DESIGN & CONSTRUCTION MANUAL DESIGN CRITERIA MODIFICATION REQUEST

PROJECT NAME: Newberry Lot 294

ADDRESS: 1460 SE Broadway Drive

Table 8-1 Proposed Peak Discharge Rates

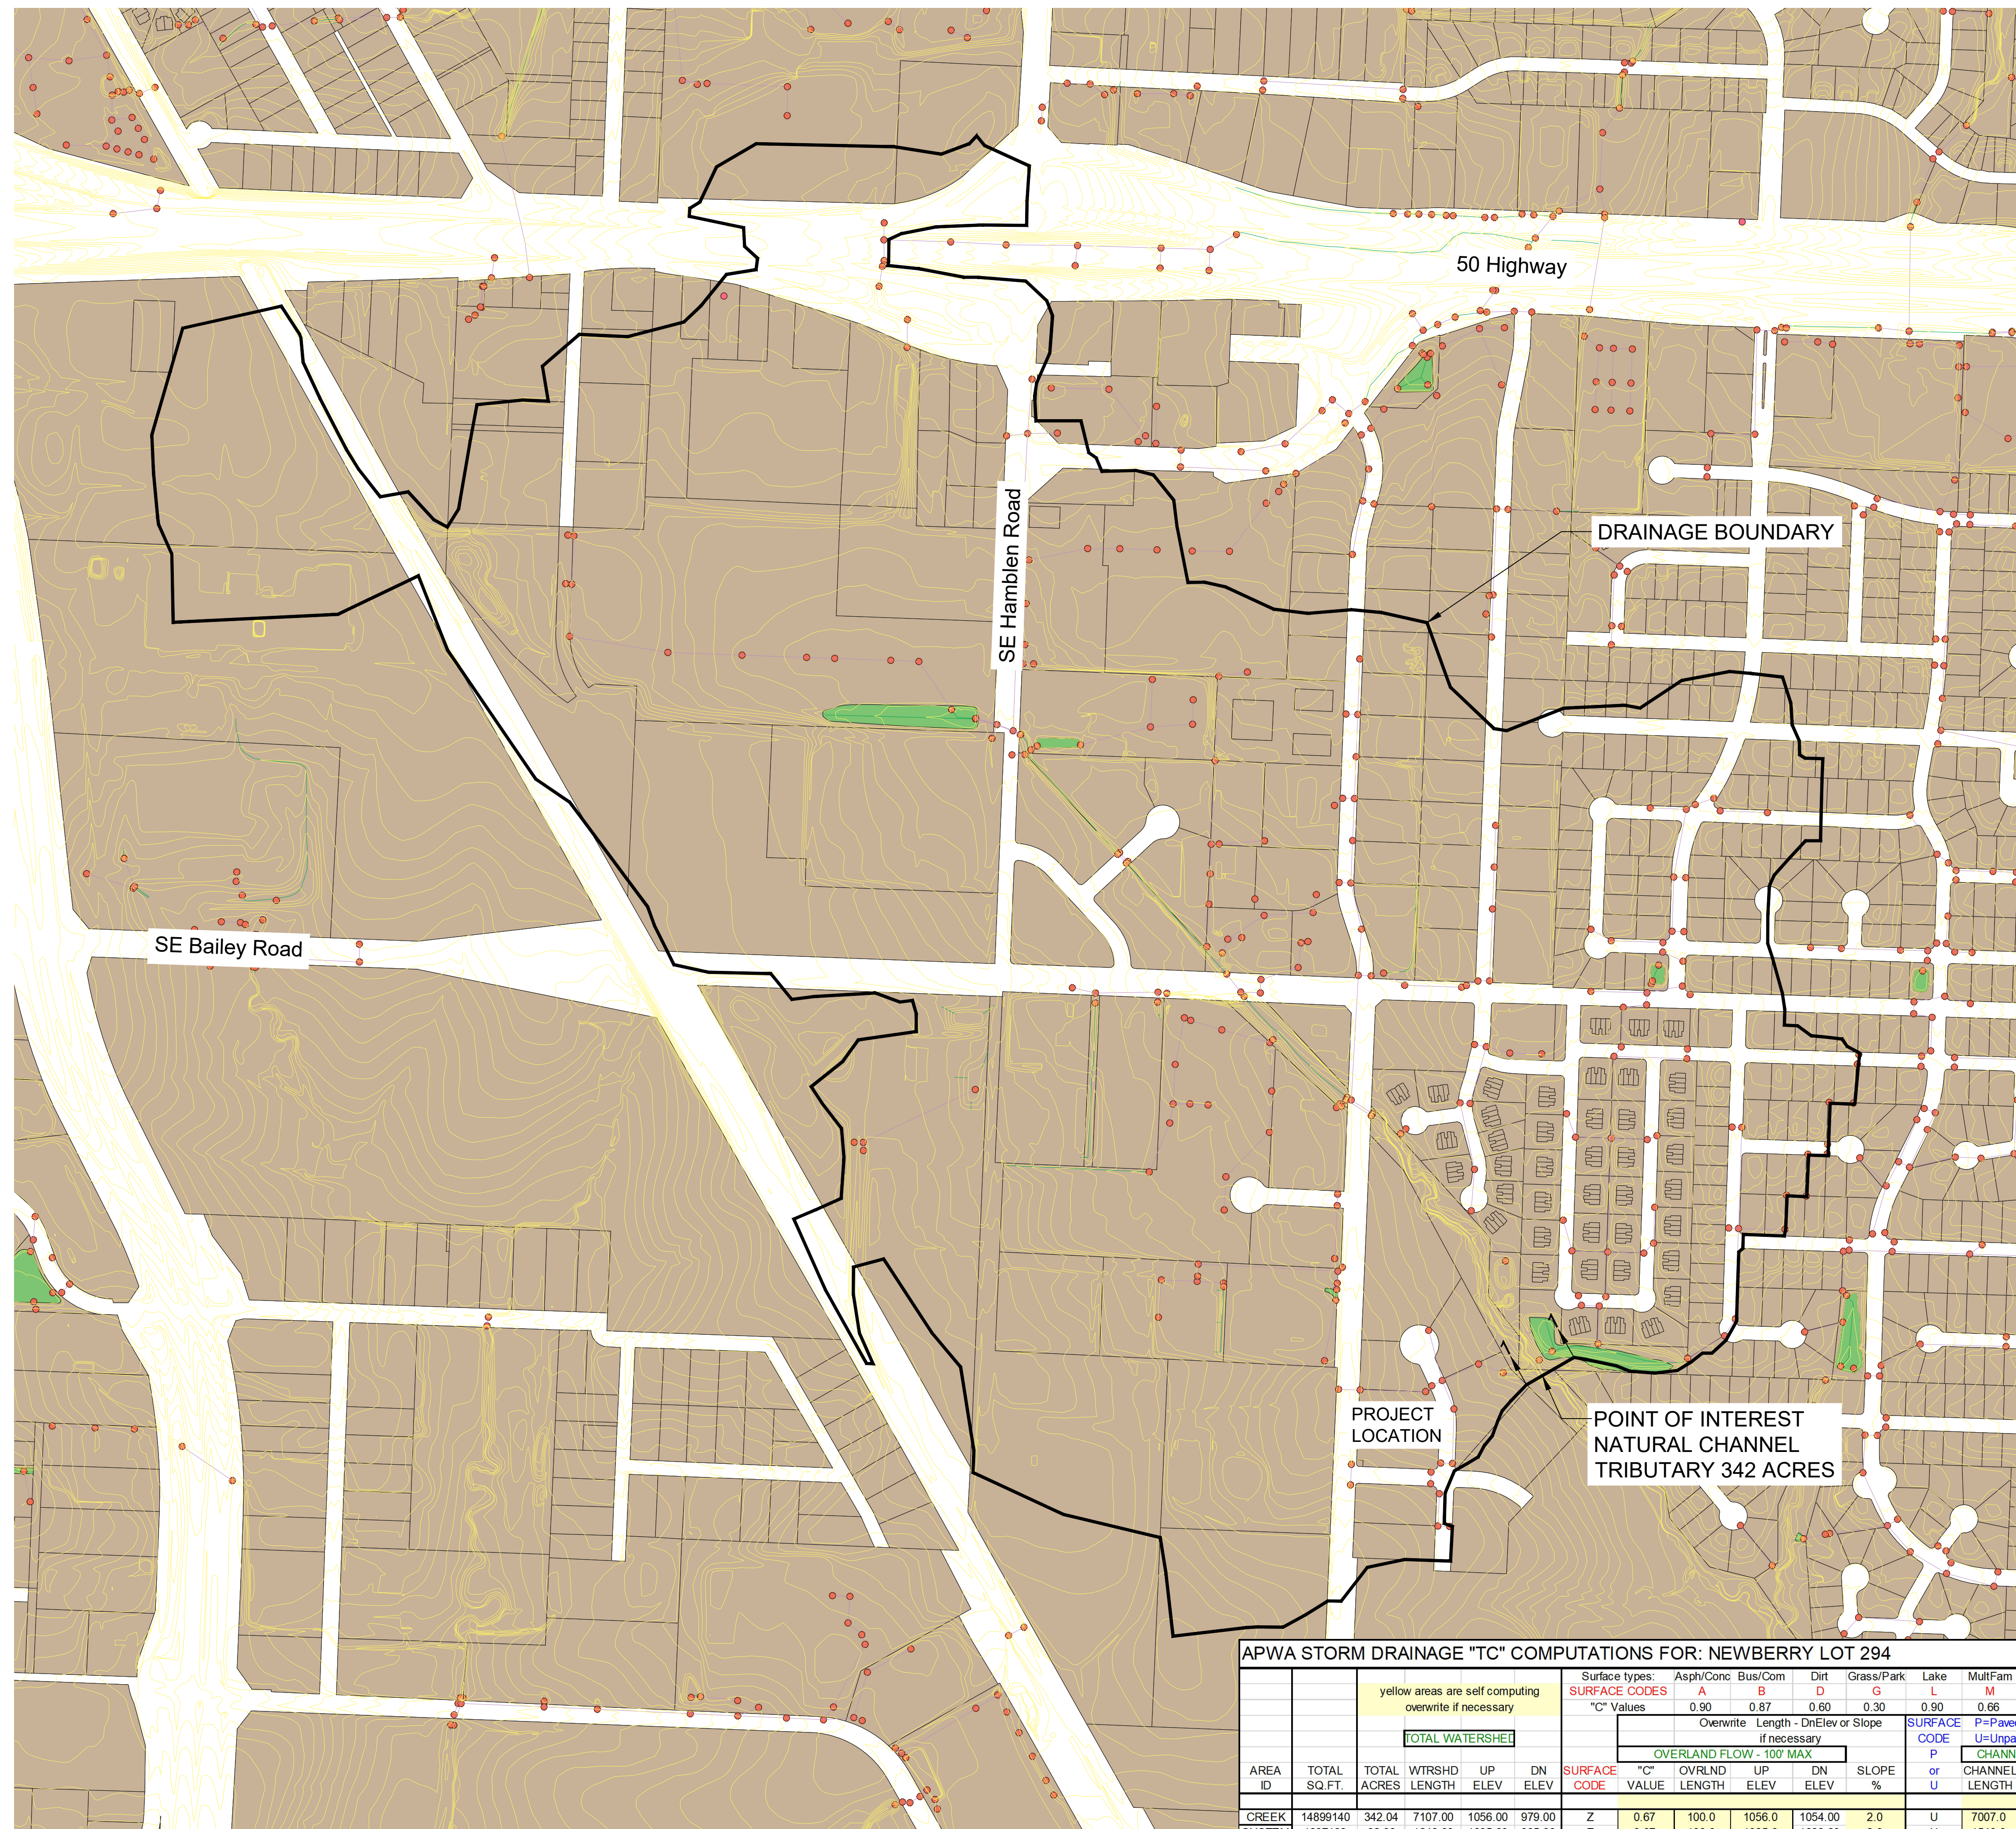
Based on SCS Methodology as outlined in APWA 5600 the proposed site will reduce peak discharge rates downstream during low return period storms. Onsite attenuation would create higher peak discharge rates downstream during low return period storms as outlined in Table 8-1 below which was taken from the macro/micro stormwater report. Please refer to the complete report if additional/complimentary information is desired.

We are requesting a waiver of Stormwater Management Facilities as identified in KC Metro APWA Section 5608. The construction of an onsite attenuation system was determined to create higher peak discharge rates downstream during lower return event storms, i.e. flood producing storms. See attachment A for additional information which supports the requested waiver. The macro/micro storm drainage study may be referenced for additional details. A hydrodynamic separator will be added on site for BMP mitigation purposes.
